## SERVICE BULLETIN

### No. SB-NG-1-22

<b>Subject:</b>	<b>Fuel &amp; Smoke Tanks Chafing</b>
<b>Aircraft affected:</b>	EXTRA NG: S/N NG001 through NG030, except for NG021 & NG023.
<b>Purpose:</b>	<p>Deflection of the tanks under g-loads may lead to contact between the tanks' bottom wall and the structure underneath.</p> <p>Damage was reported in one case where the countersunk bolts installed underneath the tanks for fixation of the fuel selector valve bracket were not installed entirely flush with the surrounding structure and consequently have damaged the bottom of the fuel acro tank. In consequence, additional rubber pads were introduced to protect the tanks from chafing in the respective areas.</p> <p>This Service Bulletin provides instructions for modification in this area in order to prevent further issues.</p>
<b>Approval:</b>	The technical content of this document is approved under the authority of the DOA ref. EASA.21J.593.

Figure 1 Center Tank – bottom view

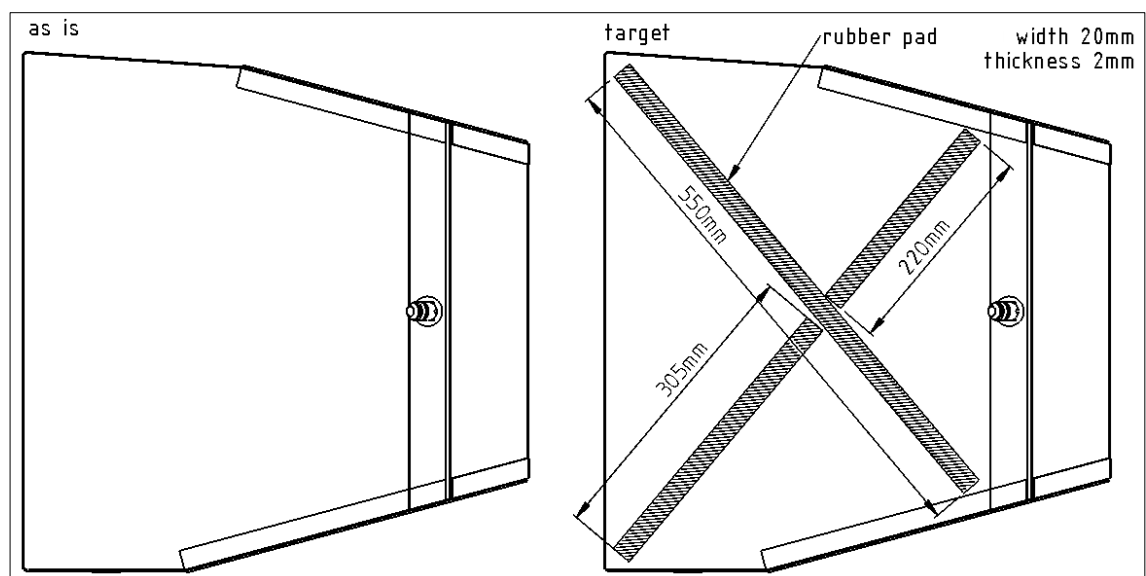
6. Thoroughly clean the lower surface of the tanks with solvent. Verify bonding surface is free from dust and grease.
7. Cut rubber pads (width 20mm, thickness 2mm) to length as necessary and glue them to the bottom side of the tanks using Cyanoacrylate (CA) or self-adhesive film if provided as per figures below:

8. Verify pads are placed directly over the attachments / bolts, then reinstall the tanks as per Chapters 28-10-01 (center tank), 28-10-02 (fuel acro tank) and 87-10-01 (smoke oil acro tank) of the AMM.
9. Reconnect the main battery and reinstall bottom fuselage access panel as per Chapter 53-30-01 of the AMM.
10. Perform engine run-up as per EXTRA NG Pilot's Operating Handbook section 4.3 and following as well as smoke system test as per section 908.2a if applicable. Check components and connections for leaks.
11. Reinstall top and bottom halves of the engine cowling as per Chapter 71-10 of the AMM.
12. Make a permanent note of the successful completion of this Service Bulletin in the aircraft logbook.  
Please also report the result of the inspection to EXTRA by returning the completed Form in Appendix A.
